### FINDLAY CITY PLANNING COMMISSION

### STAFF REPORT September 14, 2017

### **AGENDA**

SITE PLAN

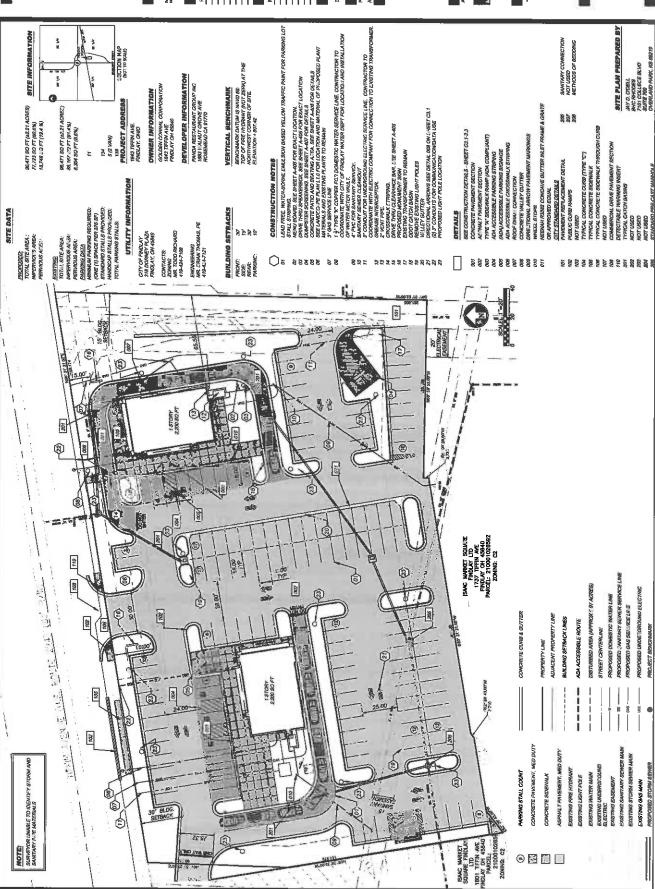
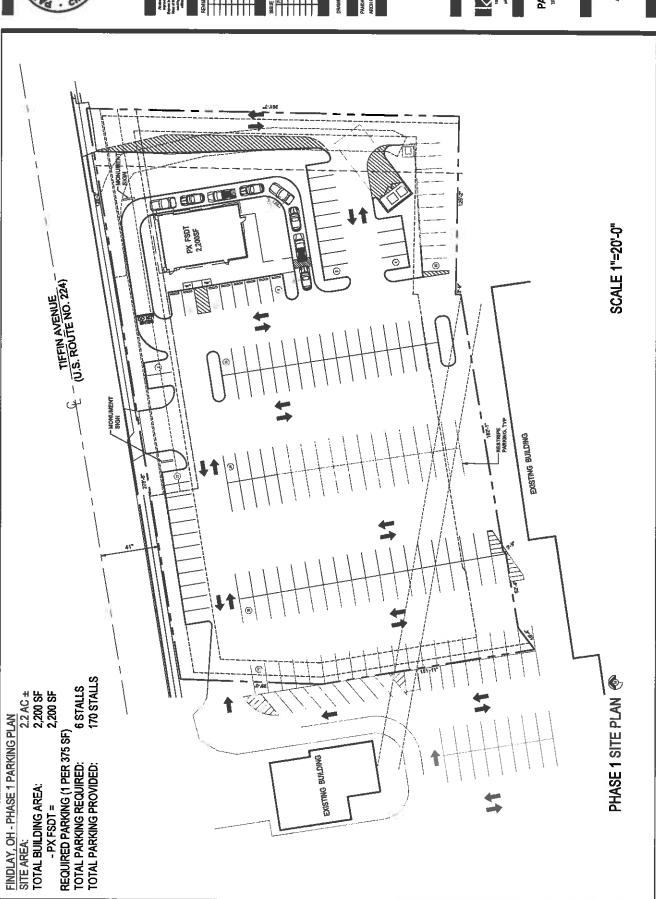
The applicant proposes to demolish the existing restaurant building and construct two new smaller restaurants on the site.

Panda Express will occupy the restaurant on the east side of the lot. Setbacks for C-2 General Commercial are 30' front, 15' side and 30' rear. The structure location exceeds all of these. The setback for parking areas is 10' from the property line. The front of the lot and the east side meet the standard. The pavement on the west and south sides are part of the total pavement shared with all the other retail in the area. Although this parcel has its own boundaries, (lot lines) traffic will flow through all areas of the shopping center and adherence to the setback along those lines is not a concern. As long as other traffic aisles are not affected, we feel it makes sense.

Access to the site from Tiffin Avenue is via two curb cuts. The first is to the east of the restaurant in an existing location. Traffic will travel south past the restaurant and then turn into the parking lot. The second, which will between the two restaurants as proposed, is a new location. It will be approximately in the center of the lot. The current drive, which is farther west, will be closed off. There is an access point shown in the northwest corner that connects with the Jimmy John's restaurant on the west. There is angled parking along the east property line of Jimmy John's and those vehicles will need to exit through the Panda Express lot. It is marked as one way on the plan.

The restaurant is requesting a drive thru window on the east side. Drive thrus are a conditional use and must be approved by FCPC. Stacking required is eight cars from the point of ordering to any road right-or-way. There is only room in the drive up aisle for four vehicles from the order point; however, additional vehicles will not be near any road right-of-way. They will only be backed up in the drive aisles within the site.

The photometric plan indicates foot-candle readings that will exceed the maximum permitted of one at some points on the property line. We recently had a similar issue with lighting at the NWO surgery center at the corner of CR 236 and Tiffin Avenue. This is a similar case of a very commercial area with a great deal of existing lighting as well as heavy traffic. The lighting does not project toward any residential uses and Staff does not feel that there will be any adverse effects. The total height of the light fixtures is 22', which falls within the 25' maximum guideline.

A dumpster is located south of the Panda restaurant. The enclosure is of materials matching the building façade and it is landscaped as required.

The proposed dumpster location is less than 10' from the property line. This will need to be adjusted.

Access – Access to the site will be from a new drive approach off Tiffin Ave. The plans show a proposed drive approach being placed east of the existing drive. The existing drive will be removed due to the relocation and a new full height curb will be installed as per plan.

Waterline- There is an existing 2-inch domestic and 6-inch fire line coming from Tiffin Ave. to feed the existing building. No proposed fire line is shown, if a fire suppression system is needed the fire line will need to be ran separately from the domestic line with its own tap. We would like to utilize these two lines for the domestic and fire line going into the new building. The location and installation of the water meter will need to be coordinated with the City of Findlay Water Department.

Sanitary Sewer- The plans propose the installation of two 4-inch sanitary sewer laterals running to the existing 8-inch PVC sanitary sewer that is located to the south of the proposed buildings. The existing 8-inch sewer is flowing towards the SE, so the 4-inch sewer lateral that is shown on the west side of the project will need to be directed towards the downstream direction.

- On page C1.0, the drive in the NW corner states "One Way Only", which direction is the one way. A pavement marking should be added to properly direct traffic.
- The new drive approach does not call out the existing curb to be cut or removed/replaced for the new curb drop.
- Will need more information on CB and MH. We will need proposed grades to check the drives and parking slopes.

The former Golden Corral restaurant has an existing UG fire line. Since the proposed Panda Express restaurant is not sprinkled, provide a city hydrant on the fire line at the drive entrance between the Beverage Barn and former Golden Choral.

Staff recommends approval of SITE PLAN APPLICATION #SP-12-2017 for a proposed 2,200 square foot Panda Express restaurant at 1843 Tiffin Avenue and another 2,200 square foot future restaurant on the west side of the parcel subject to the following conditions:

- FCPC grants conditional approval for drive thru service (HRPC)
- BZA grants the variance for the second sign (HRPC)
- The dumpster enclosure on the west side is moved to comply with setbacks. (HRPC)
- The existing 2-inch and 6-inch water lines be utilized for the domestic and fire lines. (ENG)
- The direction of flow for the west sewer lateral be switched to direct flow to the downstream direction. (ENG)
- The Waterline General Notes will need to be added to the plans. (ENG)
- The former Golden Corral restaurant has an existing UG fire line. Since the proposed Panda Express restaurant is not sprinkled, provide a city hydrant on the fire line at the drive entrance between the Beverage Barn and former Golden Corral. (FIRE)
- Apply for all necessary permits through Wood County Building Dept. (FIRE)

# SP-13-2017

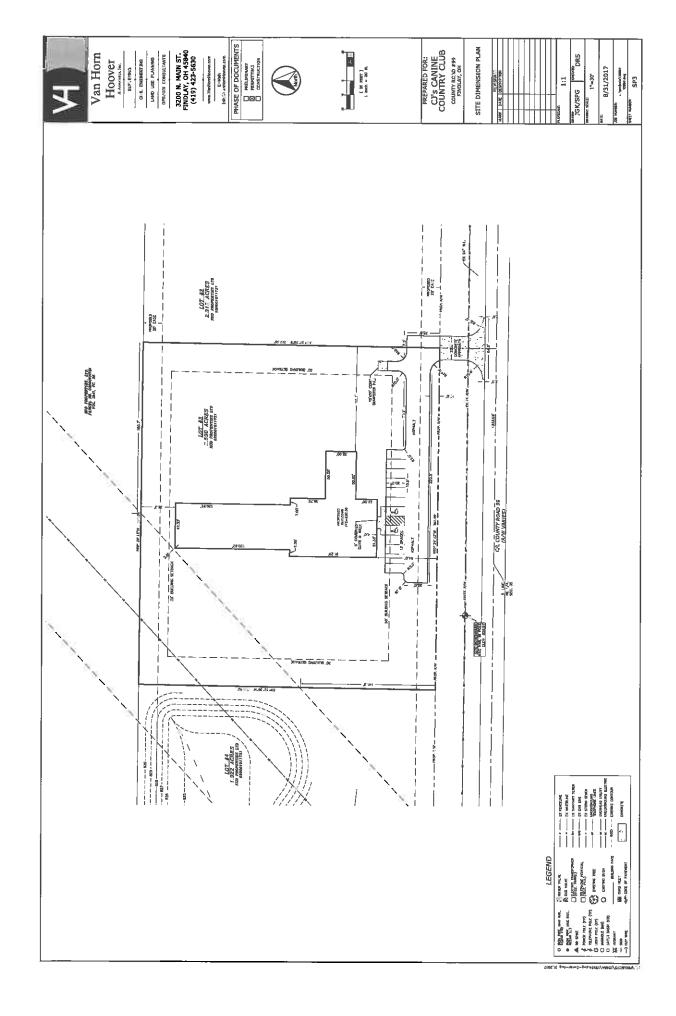
Setbacks in I-1 are 50' front and 30' on all other sides. The location of the structure meets all of the setback requirements.

Access to the lot will be via a drive entrance located at the east edge of the lot. The applicant had to go before the HRPC Highway and Transportation Committee to establish the location of any driveways onto this major thoroughfare. The Committee decided that a shared access point between this lot and Lot 2 of the subdivision was the best location.

A parking lot with 12 spaces is shown at the front of the lot. Parking in I-1 is calculated at 1.1 space per number of employees on the largest shift. The plans indicate that a maximum of five employees will be on site which calculates to six parking spaces. Because this is a single row of parking that dead ends to the west, one space will need to be striped off as not for parking at the west end. That space will be reserved for a car to turn around if it goes to the end of the lot and all the spaces are full. Otherwise, the vehicle would have to back up through the lot to get out.

There is a dumpster in the southeast corner of the lot. The plan only labels it as a dumpster pad. There is no indication of any enclosure. This needs to be enclosed particularly since it is clearly visible from the roadway.

We do not see any fencing on the property. For such a use we would assume there may be outdoor play areas for the dogs. If this is the case, the location of any fencing as well as detail on type and height need to be shown.

Because the site abuts Commercial zoning to the south, there is screening required along CR 99. (See 1161.07.4)

Sanitary Sewer – The plans propose a new 6-inch lateral to be connected to the 8-inch sewer that is located to the south of the property. The sewer lateral will be running on the east side of the building with five double wyes coming off the proposed lateral. There are also 8 proposed clean outs on the sewer lateral.

Waterline – The plans propose a 1.5-inch service line to be installed on the 8-inch waterline that is on the south side of the property. The tap and meter location will need to be coordinated with the City of Findlay Water Department.

General Comments –The floor plan shows an indoor pool, how is dog hair going to be kept out of the sanitary sewers?

Staff recommends approval of SITE PLAN APPLICATION #SP-13-2017 for a proposed

dog kennel/dog day care facility to be located at 10830 CR 99 on Lot 3 of Findlay Commerce Park North subdivision subject to the following conditions:

- Striping off the farthest west parking spot and indicating no parking (HRPC)
- Enclosure of dumpster area as required (HRPC)
- Appropriate screening along CR 99 (HRPC)
- Apply for all necessary permits with Wood County Building Department. (FIRE)

# SP-14-2017

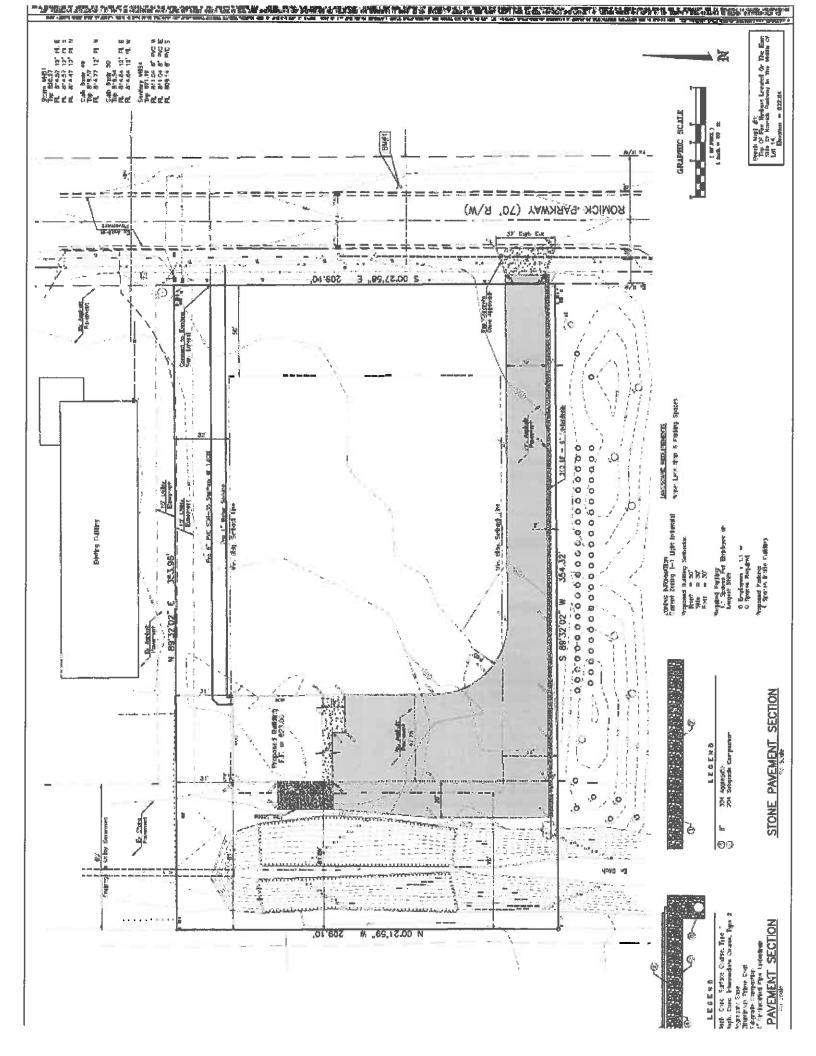
The applicants are proposing a 2375 square foot storage building in the northwest corner of the parcel.

Setbacks in the I-1 District are 50' front, and 30' and all other sides. The building is located within those requirements.

Access to the site will be via a driveway located at the southeast corner of the lot. A 22' wide drive will go west through the parcel and turn north where it widens to a 67' wide pavement up to the proposed building.

Parking for industrial sites is calculated at 1.1 space per employee on the largest shift. The plan states that there are no employees. It also states that four parking spaces are available inside the building.

Access – Access to the site will be from a new drive approach off Romick Parkway. The plans propose a 32-ft. curb cut to come off the west side of Romick Parkway

Waterline- The plans propose a 1-inch service line to be tapped onto the 8-inch waterline that is on the east side of the property. The tap and meter location will need to be coordinated with the City of Findlay Water Department.

Sanitary Sewer- The plans propose a new 6-inch lateral to be connected to the existing sanitary lateral that is located on the NE corner of the property.

Staff recommends approval of SITE PLAN APPLICATION SITE PLAN APPLICATION #SP-14-2017 for a proposed 2,375 square foot storage building on Lot 14 in the Deer Meadows Subdivision subject to the following:

• Apply for all necessary permits through Wood County Building Dept. (FIRE)
